Access Compliance Report

Public Rights-of-Way (Curb Ramps)

Intersection ID: N/A	Main Street: ECHODALE_DR	Cross Street: DUNBROOK_LN	Location: NE
ADA ID: FEC6398F2F10	Ramp Type: Directional1	Initial Pass/Fail: Fail	Overall Compliance: No
Codes/Mitigation Info/Possible Solution		Field Measurements/Component Compliance	
Severity Score: 33.75

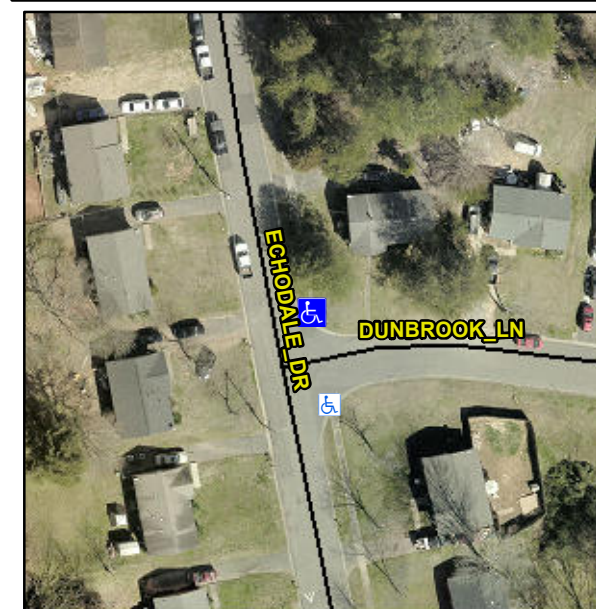
R304.5.1, R304.2.2

Remove & Replace Entire Ramp.
